Keowee Overhead emergency power path seismic
qualification & analysis request for addl
info.....

RE: Oconee Nuclear Station
Docket Nos. 50-269, -270, -287

KEOWEE OVERHEAD EMERGENCY POWER PATH
SEISMIC QUALIFICATION AND ANALYSIS
REQUEST FOR ADDITIONAL INFORMATION

Figure 1

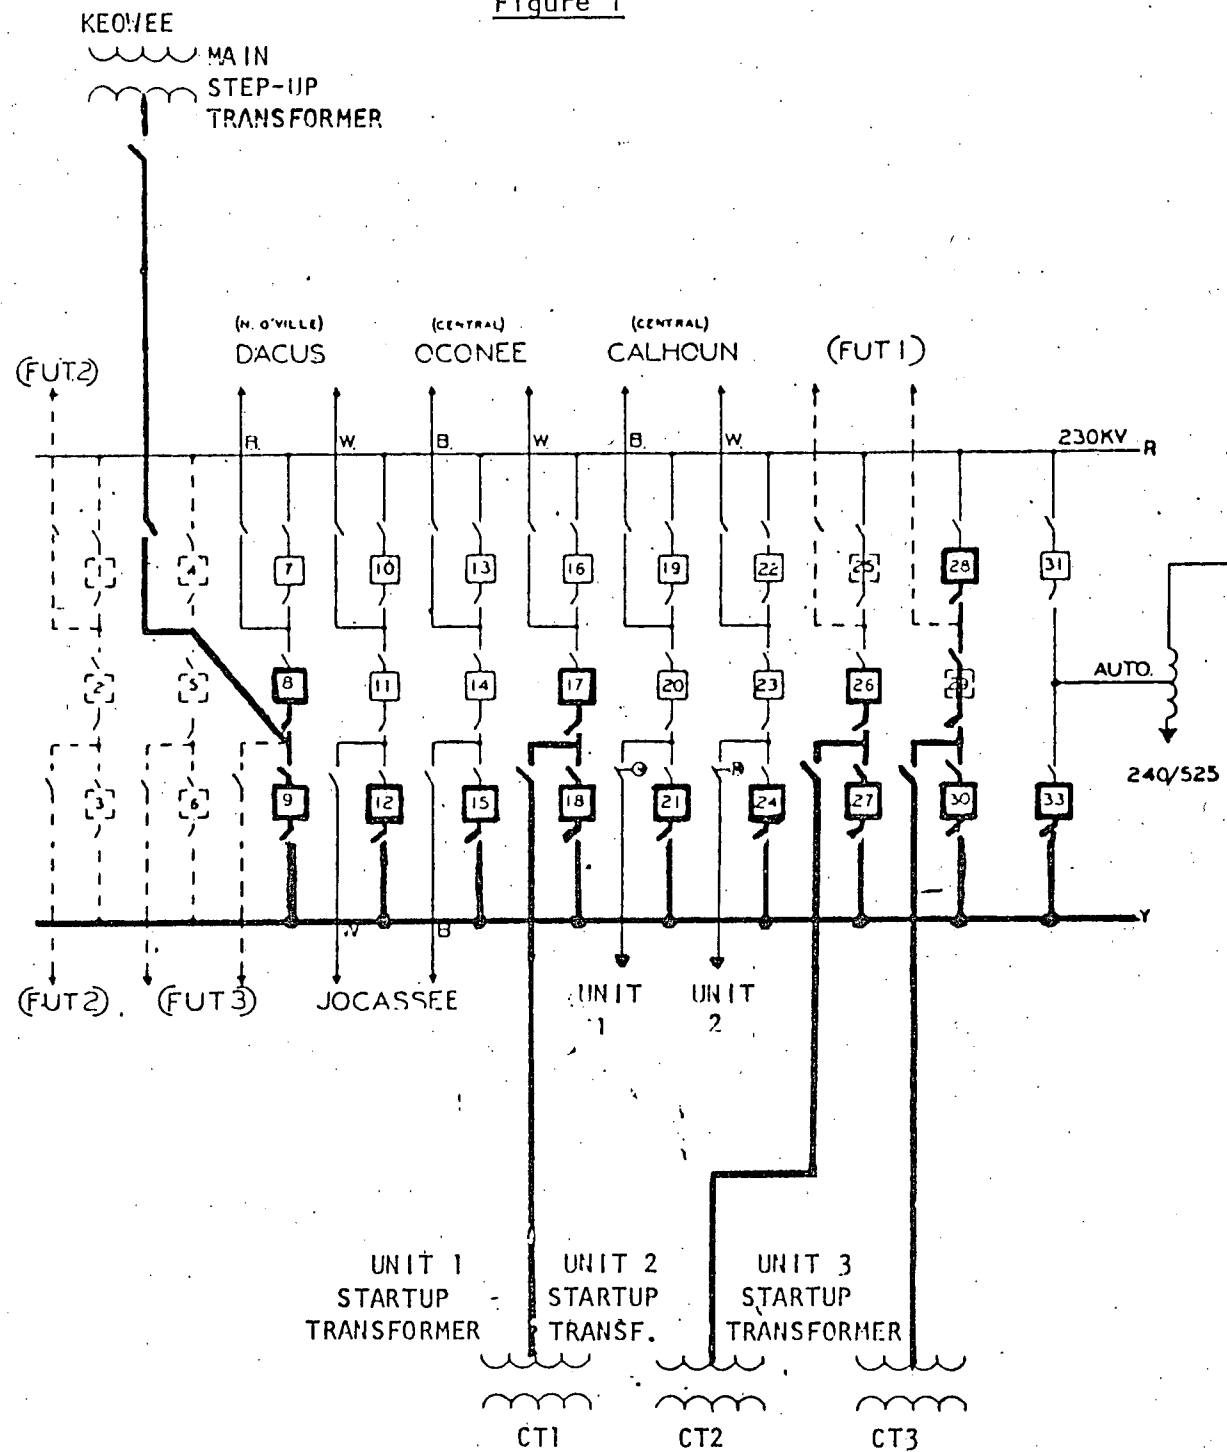
The Keowee Overhead Emergency Power Path is shown in bold lines on Figure I.
